Premises: Grenfell Tower, Testerton, Barandon and Hurstway Walks on the Lancaster West Estate

Thank you for asking me to comment on the questions raised by the London Fire Brigade (LFB) officers during they visit to the above buildings on the Lancaster West estate on the 12th March. The LFB fire officers were Ben Lewis, Mathew Ramsey and Dan Hussey and you were accompanied by Mr Bruce Sounes of STUDIO E, the questions asked were contained in your e mails to me from notes that were taken during the visit. I visited the above premises yesterday, Monday the 17th March 2014 to gather the information for this report, the information on service dates etc was obtained from the contractors servicing and maintenance logbooks held on site and from records from the TMO's engineers section at the Hub.

Dry rising main

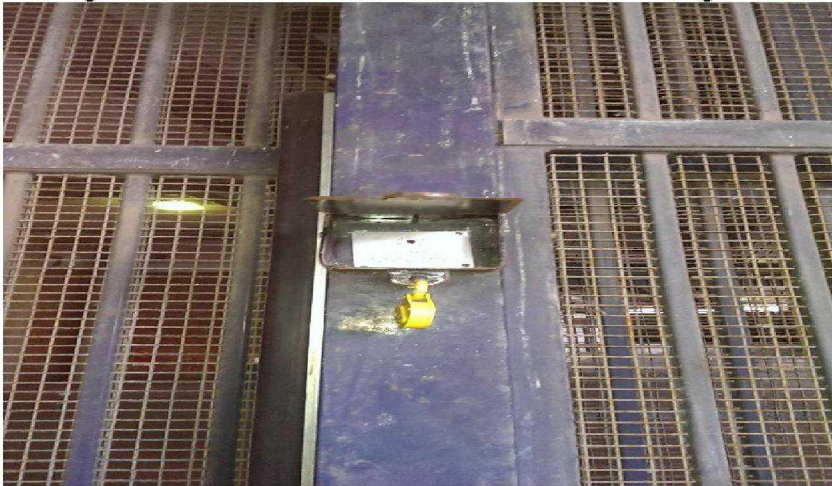
There are dry rising mains installed in these finger blocks, the inlet is located at the lower ground floor level, in the areas underneath the residential areas with the outlets being located directly above the inlets. Each riser is numbered with black paint on the front of the dry riser box, so number 6 dry riser inlet feeds number 6 dry riser outlet which is located directly above it. The dry risers in Testerton and Hurstway Walks were last tested by M and P Fire Protection Limited on the 30th December 2013 according to the contractors label fixed inside these inlet and outlet boxes. Please see the recommendation reference Barandon Walk. Located above the dry riser inlets there is another red painted box this contains an outlet from a ring main, this is different from a town main which is the normal way for water to be provided. As far as I am aware this ring main was installed when the premises was constructed, it could have been considered that a wall mounted water ring main would be easier to maintain than an under ground hydrant one. A ring main is a recognised way of providing water to inaccessible places it also has the advantage that the fire service do not need to use a standpipe key and bar etc when connecting to it. In this case this is a water filled pipe above ground rather than underground which is maintained serviceable by the TMO, the last test was undertaken by M and P Fire Protection Limited on the 29th November 2013 according to the contractors label fixed inside the ring main boxes. The water pressure at the time of this last test was 4.4 bar.

How this system is used by the fire service is a matter for them to decide, also it is up to them to decide if they drive fire appliances into the lower ground floor level roads to apply pressure to the system so that they have a fire fight jet on the upper floor levels. There have been different padlocks fitted to the ring main boxes that the normal FB padlocks, the currently fitted padlocks should be removed and the standard FB padlocks fitted so that the LFB can open the boxes easily.

9. There have been different padlocks fitted to the ring main boxes that the normal FB padlocks, the currently fitted padlocks should be removed and the standard FB padlocks fitted to each ring main box so that the LFB can open the boxes easily.

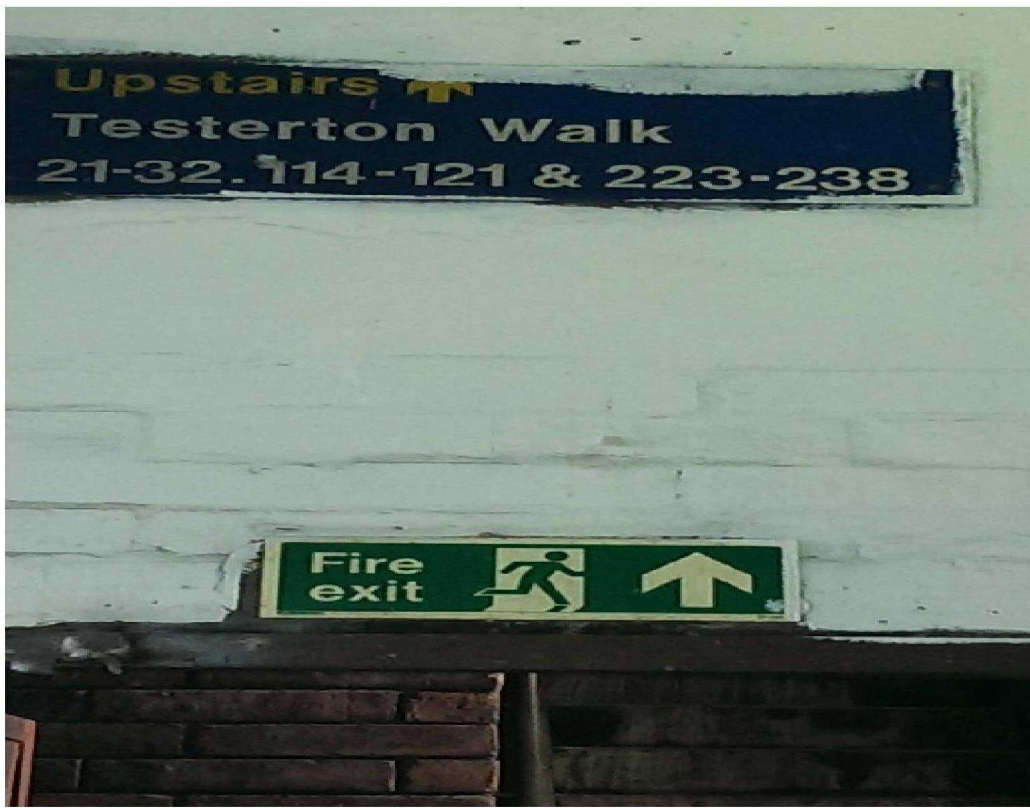
The fire officers commented on the storage of flammable materials in the OCS cleaners store of Hurstway Road. This is a garage area where cars can be parked and garaged with upwards of 100 litres of petrol in their fuel tanks, this garage area was designed to

have cars parked in it containing flammable liquid. When I looked in the OCS storage area yesterday there were two 5 litre purpose made green plastic petrol containers stored here. This petrol is used for the leave blowers, I do not believe that any further action is needed on this issue.
